NUREG-1573

A Performance Assessment Methodology for Low-Level Radioactive Waste Disposal Facilities

Recommendations of NRC's Performance Assessment Working Group

Manuscript Completed: October 2000
Date Published: October 2000

Figure 3. **Section 3.1: Detail to the "Example of an Acceptable Process for Demonstrating Compliance with 10 CFR 61.41."** The activities shown by the dotted lines depict the compliance review the NRC staff is expected to perform.

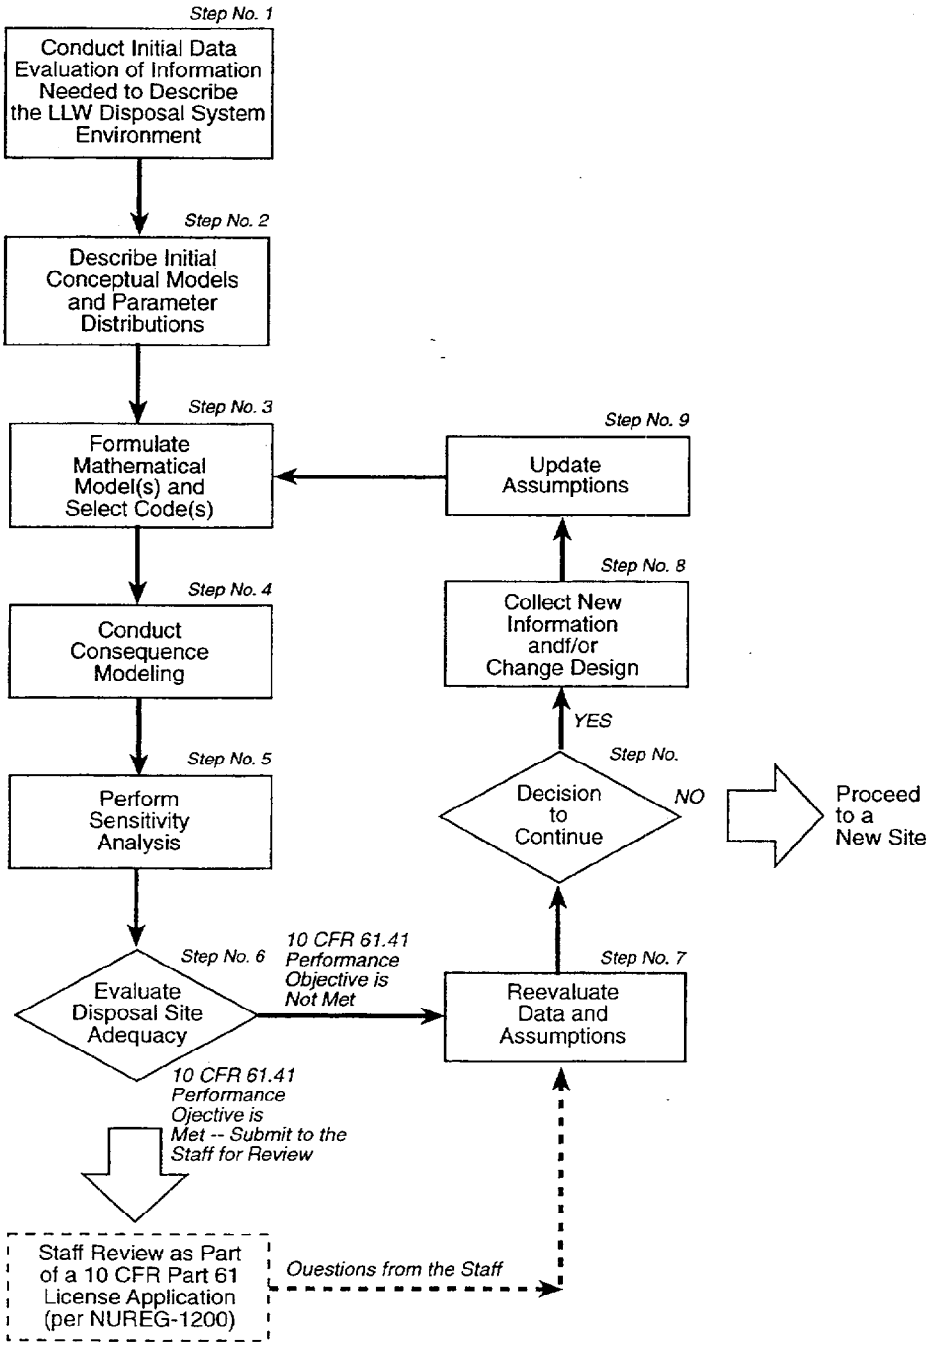
11. Page 3-2; "Branch Technical Positions (With Discussion)," Figure 3. Where does the option of limiting radionuclide inventory fit into this flow chart? Limits on radionuclide inventory may change a disposal site's rating from "inadequate" to "satisfactory."

7. Page 1-15, Paragraph 3. We strongly concur, and hope that the regulators are able to participate in such a process without compromising their objectivity. This might be indicated on Figure 3 [Technical Position 3.1: Detail to the "Example of an Acceptable process for Demonstrating Compliance with 10 CFR 61.41"], if appropriate.

In practice, the PAWG believes that the approach outlined in Section 3.1 of this technical report (and depicted in Figure 3) should result in a supportable demonstration of compliance with 10 CFR 61.41. *Step No. 6* of the process is the logical ending point for the required assessment; specifically, having

Response
As noted in the response to *Golder Associates' General Comment No. 6*, the PAWG believes one of the tenants of good and effective regulation is to interact early and frequently with potential licensees. With this philosophy in mind, the NRC staff (or any other State regulatory authority) would, at the request of potential licensees, interact on any or all of the LLW performance assessment process steps described in Figure 3.

Figure 12. **Conceptualization showing potential surface water contamination pathways.** (All radionuclides distributed in the aquifer, in the vicinity of the surface-water body, are discharged into it.)

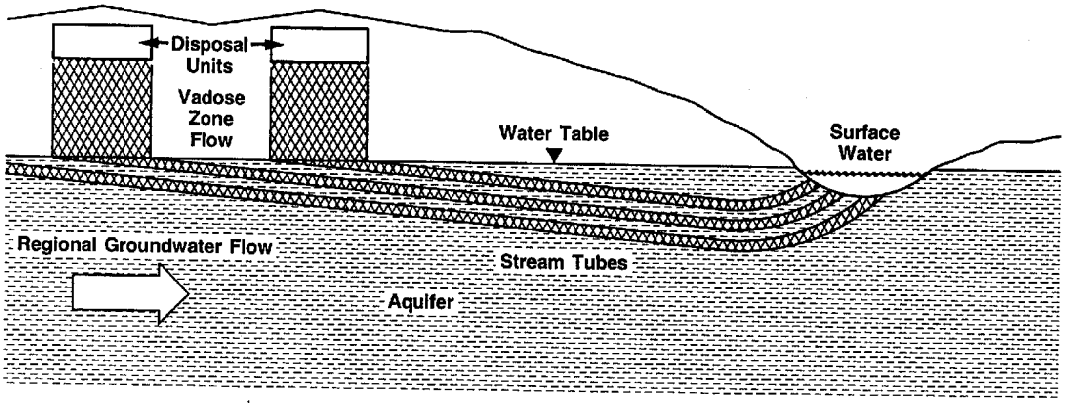
5. Section 3.3.6.2.1, "Surface Water. Considerations" (p. 3-61): The first sentence of this section references Figure 13. Figure 12 appears to be the more appropriate reference.

Figure 14. Example of potential dose pathways to be considered in an LLW performance assessment. [Determination of appropriate pathways depends on site-specific information (i.e., habits of the critical group). Adapted from EPA (1972).

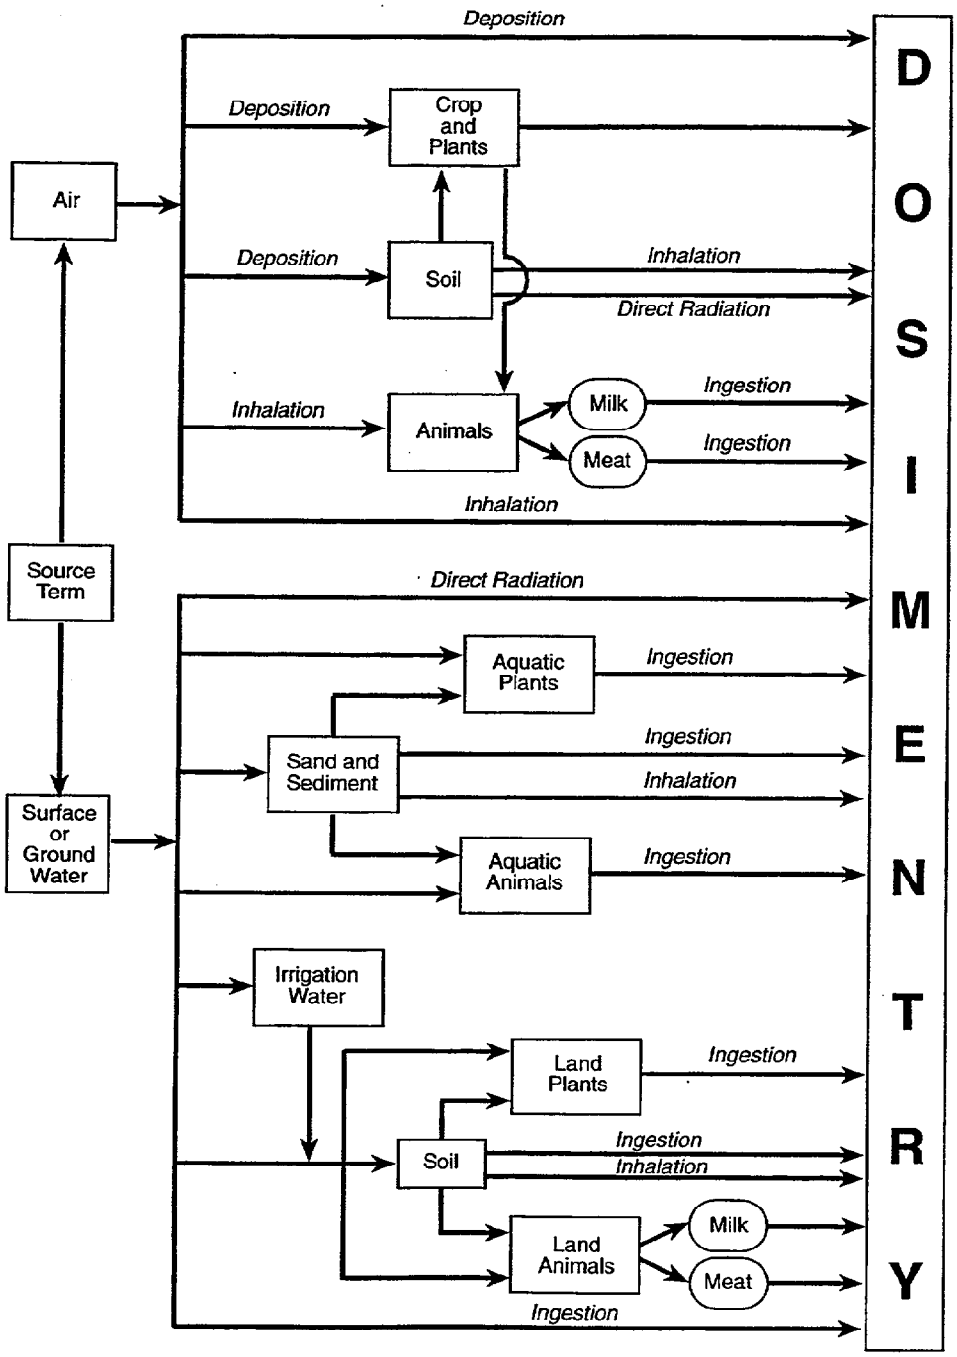
2. Page 3.75, Figure 14, this figure contains an unusual label [sic] "Fishing and Sports Gear." If this level of specificity was used uniformly throughout the diagram it may become too cluttered to be useful.

7. On Figure 14, the mechanism by which exposure is received by the individual (i.e., ingestion, inhalation, direct radiation) is identified in italics for some but not all of the pathways depicted. Specifically, the milk and meat pathways at the bottom of the figure should specify "ingestion," and the fishing and sports gear category and sand and sediments category should specify "direct radiation "if that is the intent.

Response
The PAWG agrees with this comment. Figure 14 has been revised accordingly.

Response
Figure 14 has been revised based on these comments.

Figure B-2. PAWG-recommended approach to calculating the peak of the mean dose.

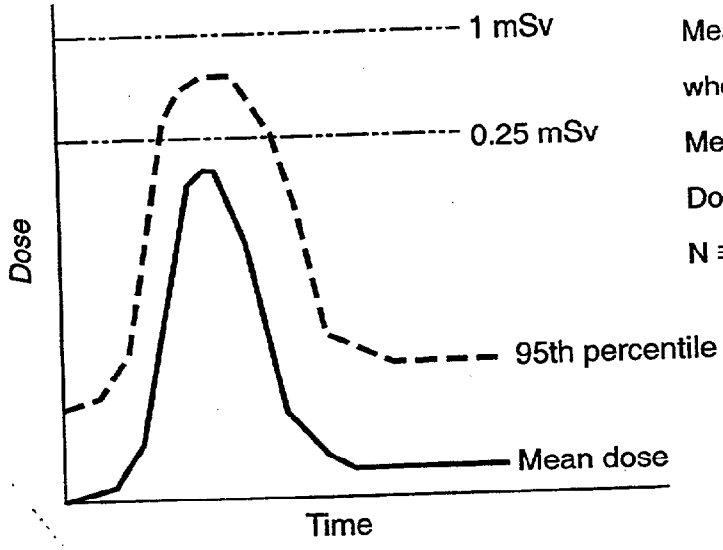
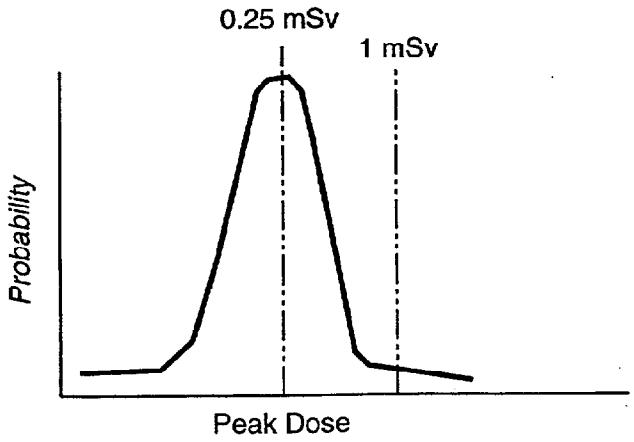
disposal system and is the most direct measure of risk. See Figure B-2. Further, placing a limit on the upper 95th percent confidence of the dose distribution provides additional assurance of the acceptable performance of the site – constraining the 95th percentile of the distribution to 1.0 milliSievert (mSv) [100 millirem (mrem)], as shown in Figure B-2. [In response to this and other comments, the PAWG staff have modified Paragraph No. 2 of Section 3.3.2.3.2 of this technical report ("Probabilistic Analysis") to describe how the mean dose as a function of time can be derived mathematically, consistent with Item (a), shown in Figure B-2.]

Essentially, a mean dose is determined at each discrete time-step in the analysis. A plot is then made of these means versus time. The mean dose provides the "best estimate" of dose at each discrete time. The overall peak of these best estimates is then used to determine compliance with the regulation.
